March 2, 2020

Natalie O'Grady  
Avatiliriniq Coordinator  
Government of Nunavut

GN-01: Terrestrial Wildlife Effects	
<b>Department</b>	Environment
<b>Organization</b>	Government of Nunavut
<b>Subject/Topic</b>	Terrestrial Wildlife Cumulative Effects
<b>References</b>	<ul style="list-style-type: none"> <li>• NIRB Application for Screening #125502 – Ulu Gold Project – Blue Star Gold Corp.</li> <li>• NIRB Public Notice of Screening and Comment Request for Blue Star Gold Corp.'s "Ulu Gold Project" Project Proposal</li> <li>• Effects Assessment (2020) – Ulu Gold Project – Blue Star Gold Corp.</li> <li>• Environment and Heritage Resources Protection Plan (2020) – Ulu Gold Project – Blue Star Gold Corp.</li> <li>• Project Description (2020) – Ulu Gold Project – Blue Star Gold Corp.</li> <li>• Wildlife Protection Plan (2020) – Ulu Gold Project – Blue Star Gold Corp.</li> <li>• The Bathurst Caribou Range Plan (2018) – Government of the Northwest Territories.</li> <li>• Environmental Dynamics Inc. (EDI). (2008). Yukon Environment - Flying in Caribou Country – How to minimize disturbance from aircraft</li> <li>• Poole, K.G. and Gunn, A. (2015). Mobile Caribou Conservation Measures for the

**Figure 1:** Ulu Gold and Hood River Projects in Relations to Bathurst Caribou Seasonal Ranges – Large Scale

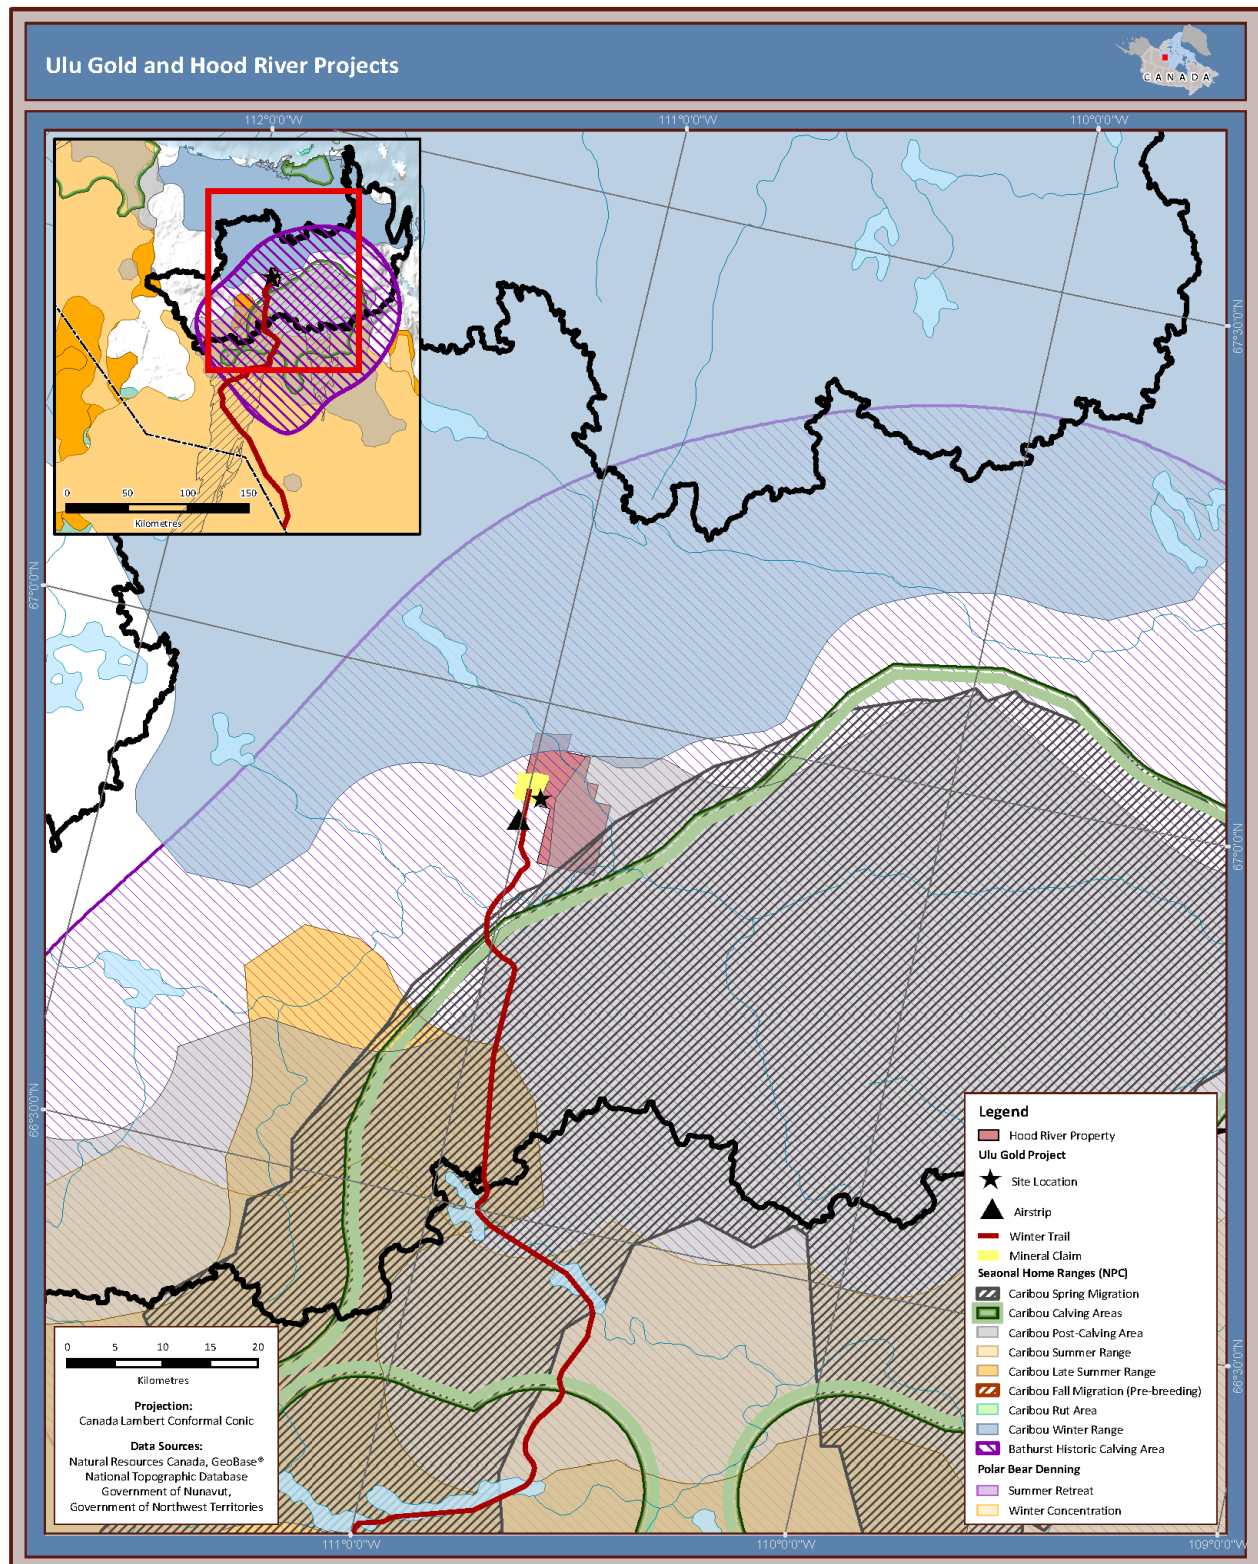
and Dolphin-Union caribou herds. As such, Project activities may affect caribou spring migration and calving. The Project area is also in proximity (1-11 km) of the calving area, post-calving areas and within the historic calving area of the Bathurst herd (Figures 1 and 2). The potential impacts of the Project activities may affect these areas and cause disturbance during caribou calving, post-calving, and migration.

Further, the GN recommends the NIRB consider the location of the proposed new camp infrastructure, fuel storage facilities, and exploration activities be limited to areas well outside the seasonal ranges and migration corridors of the Bathurst caribou herd.
